ADDENDUM NO. 1
CATA IFB #2013-107

June 21, 2013

RE: East Lansing Multi Modal Transit Center
Capital Area Transportation Authority
East Lansing, Michigan

DRAWING NO: **CSK-03**

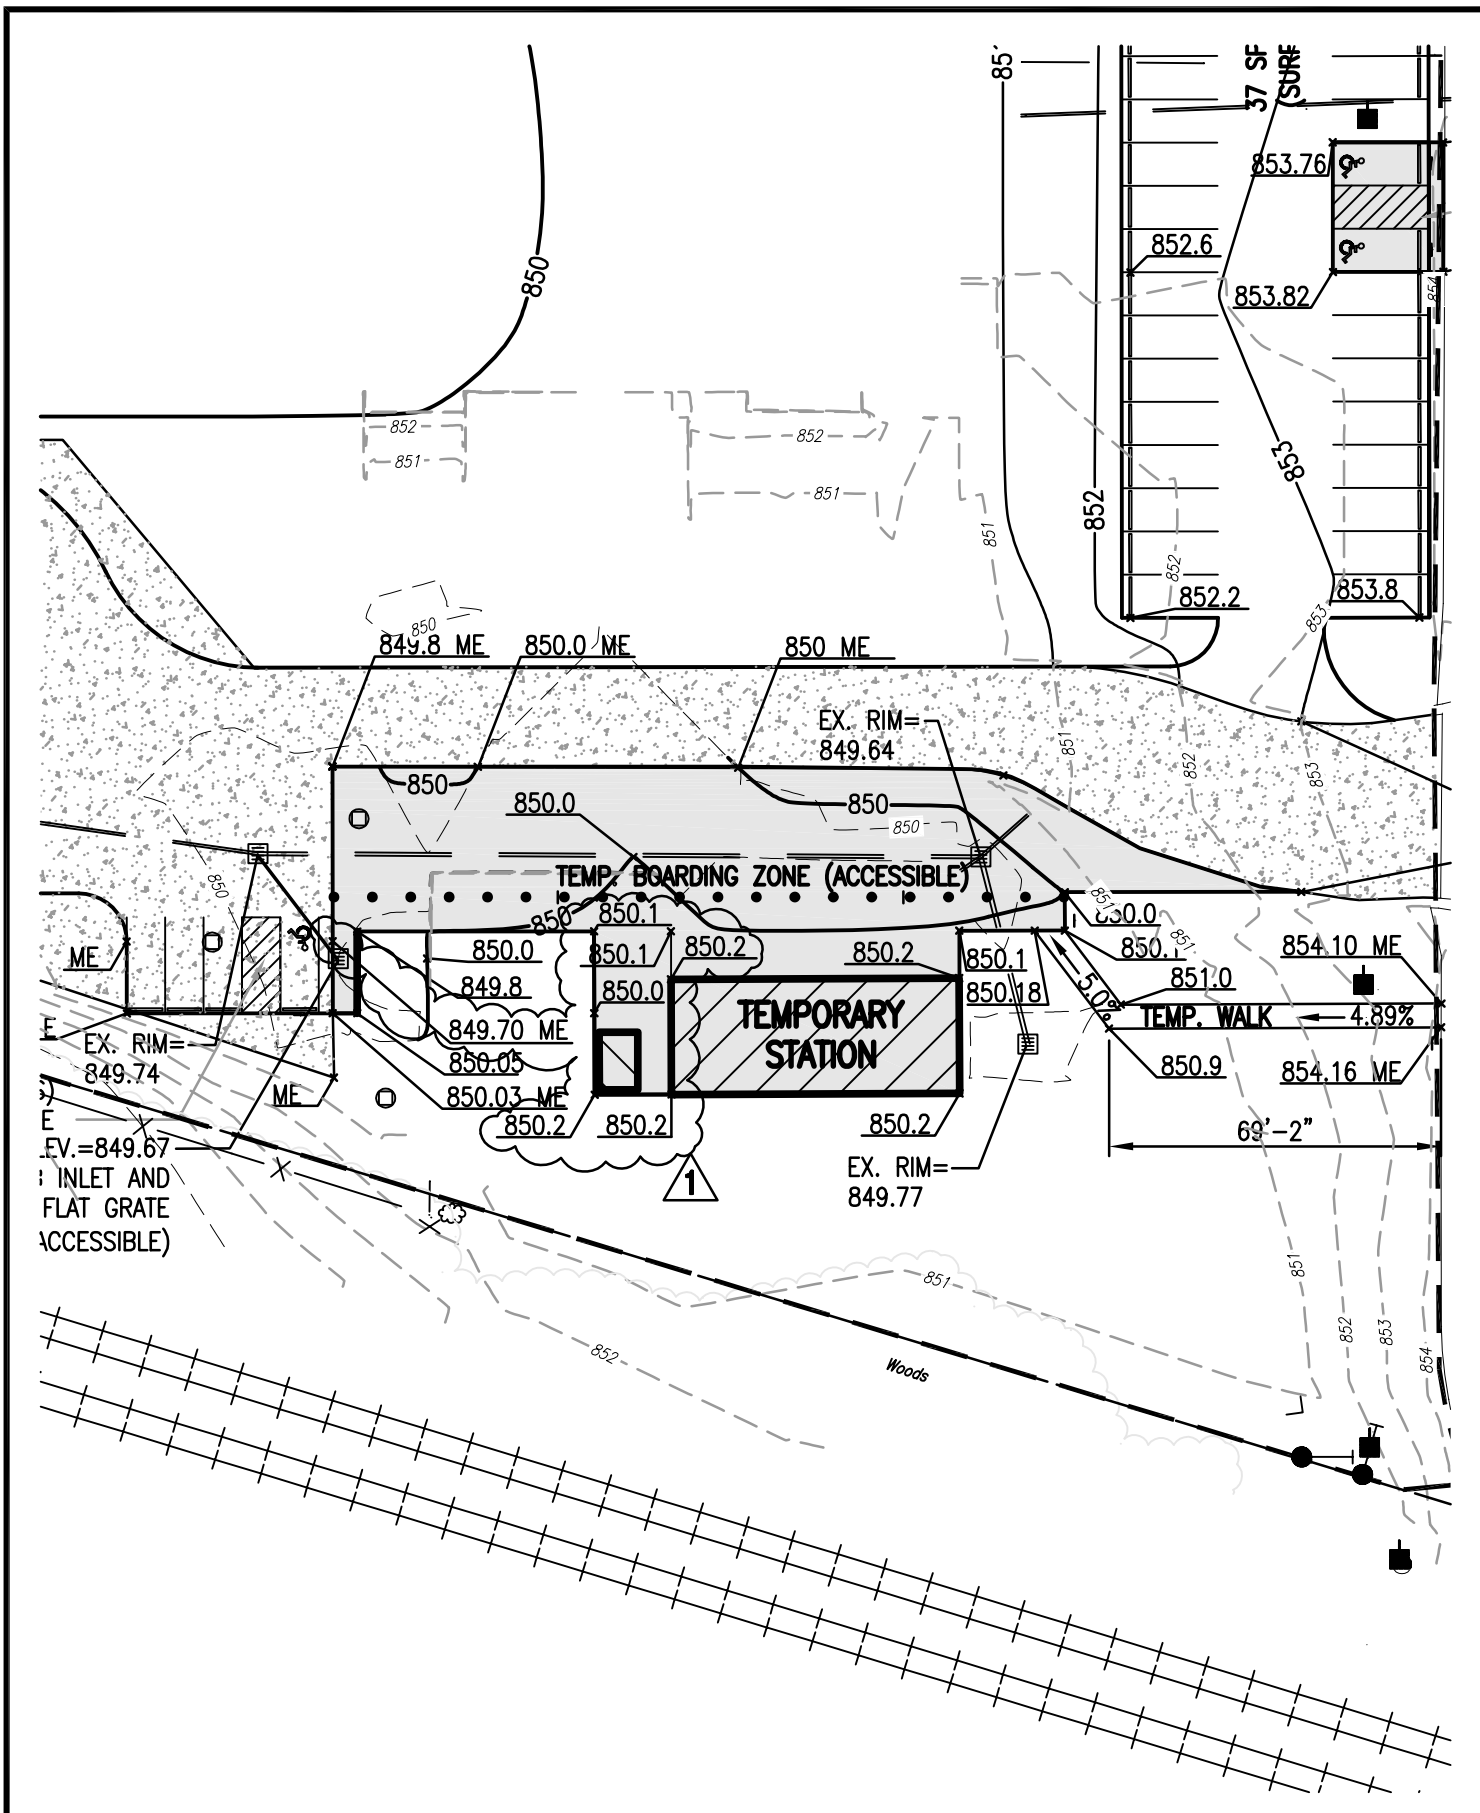
<u>Drawing Sheet No.</u>	<u>Detail/Item</u>	<u>Action</u>
GN1.2	Milestone Area 1	Revise "29 Calendar Days" to read "22 Calendar Days". Revise "August 16" to read "August 9".
C2.0	General Notes	Revise General Note 12. and 20. Refer to Sketch CSK-03.

C2.0	Legend	Bottom of Sheet Legend. Clarification. Temporary Station and Temporary Sanitary Holding Tank pad shall be asphalt not concrete. Refer to Sketch CSK-03
C3.0	General Notes	Add. Item 8. Temporary sanitary waste and waste holding tank. Refer to Drawing Number C2.0, General Note 20 for Contractor responsibilities. Site Improvement Key Add. Item 10 Route to Rail Boarding Area Signage; Item 11 Transit Center Parking Signage; Item 12 Bus Loading Zone Signage; Item 13 Temporary Sanitary Waste Tank, Refer to General Improvement Notes 8; Item 14 Lawn Restoration/Renovation, Refer to Spec Section 329200; Item 15 Temporary Soil Stabilization, Refer to Spec Section 329200; Item 16 Service Access, Aggregate Base, 4", MDOT 22A, CIP. Plan has been revised and supplemented with the additional improvement items (10-16).
	Legend	Add. Hatch pattern identifying Temporary Soil Stabilization (No Topsoil) and Hatch pattern identifying Lawn Restoration/Renovation.

DLZ Project Number 1341-6517-70
DATE: 6-20-13
SCALE 1"=40'
DWG: C4.0
DRAWING NO: **CSK-04**

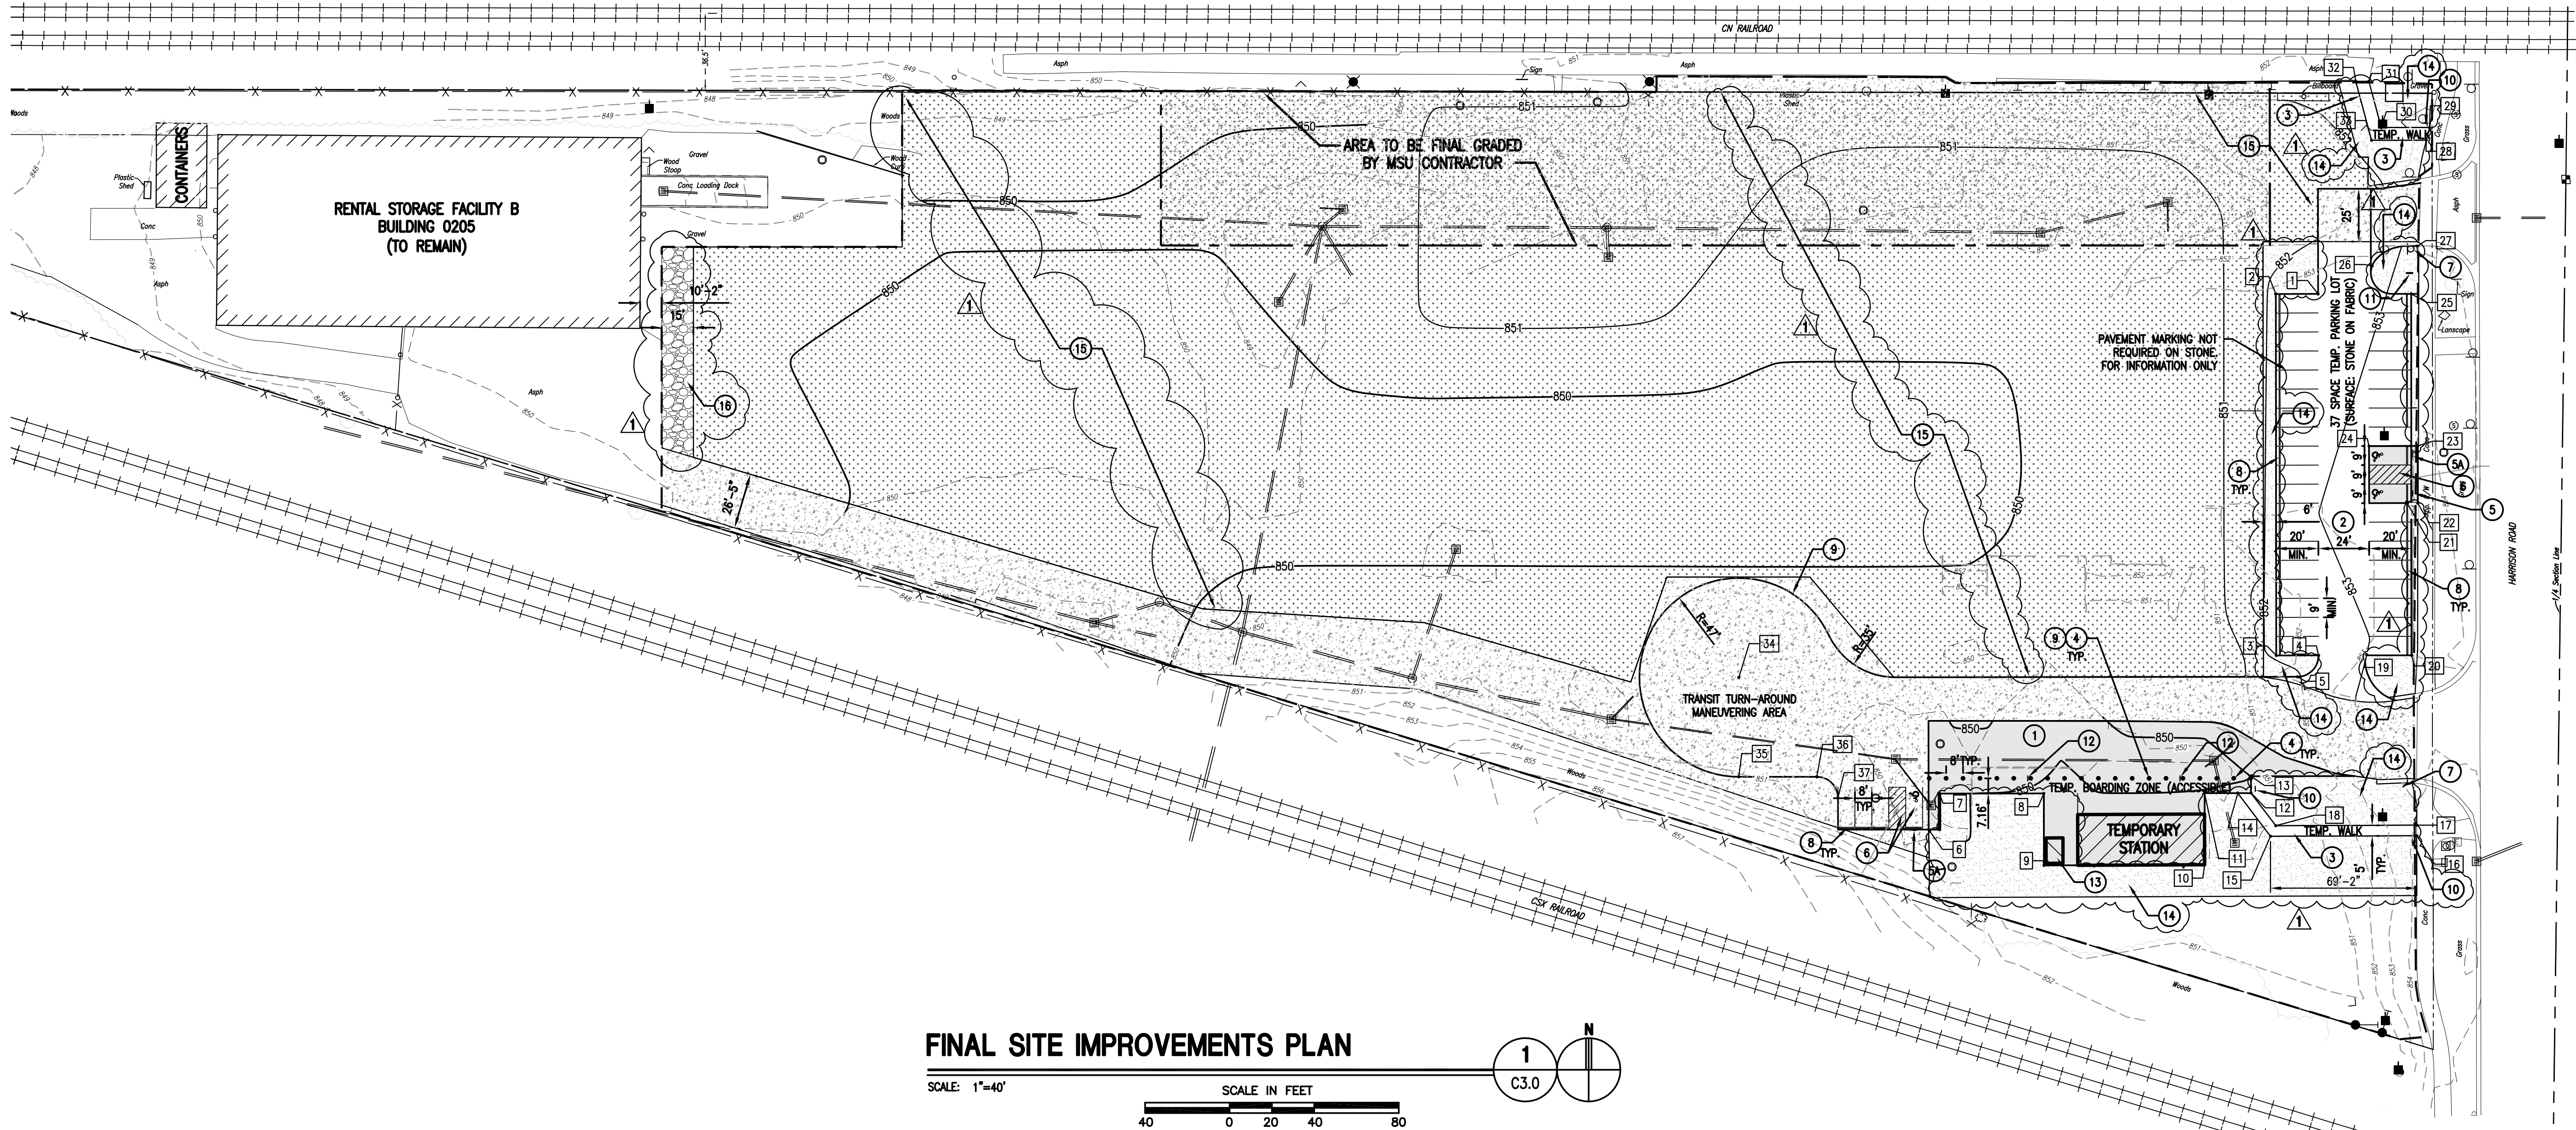
Improvement Coordinate Schedule	Update. Coordinates 8 & 9. Proposed asphalt pad revised and expanded west of temporary station 16'x34' to place and access temporary sanitary holding tank.
C4.0	Temp. Station Pad	Spot elevations provided at edge of expanded asphalt pad (for temporary sanitary holding tank). Refer to Sketch CSK-04
C5.0		Clarification. Exposed soil areas on the site resulting from site removals, pavement removal, building demolition, soil remediation, and utility removal are not to be restored with topsoil. Temporary Soil Stabilization measures have been specified (refer. 329200). This intermediate measure is intended to stabilize the exposed soil resulting from this project. All perimeter silt fencing and siltation protection at drainage structures shall remain at the end of the project. These temporary intermediate measures will be maintained and removed later by a separate contract. Lawn restoration seeding is shown on the Drawings and is

intended only in areas adjacent to temporary station, temporary parking lot, and pedestrian access/walk to the ex. rail passenger boarding area.

CONTROL MEASURES

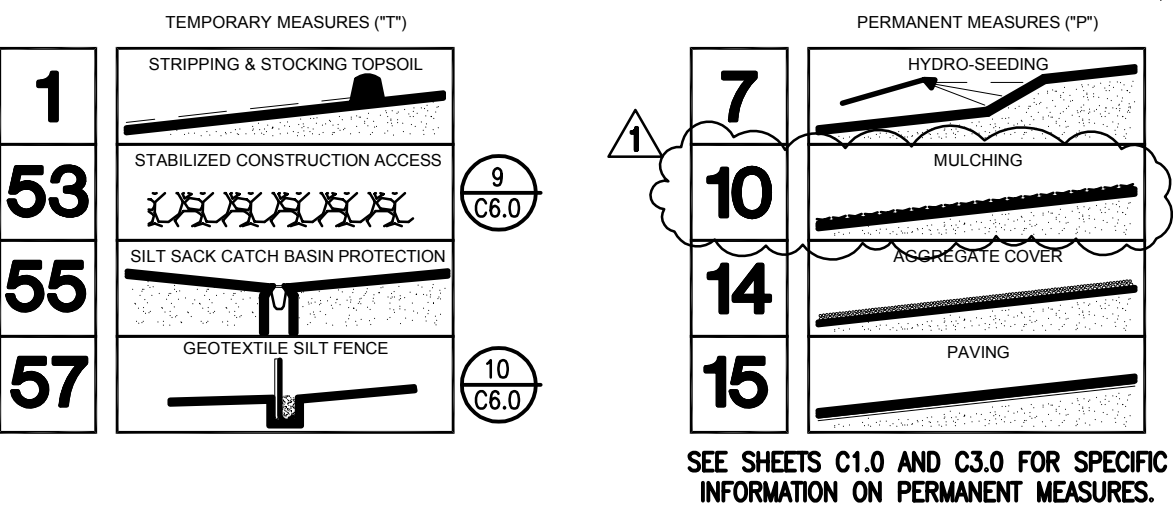
Control Measure 10 has been added to the SESC Legend. Bar chart has been provided depicting Construction Sequence / Operation Time Schedule.

Correction. Item 12. Gradation for crushed aggregate should be 6AA.
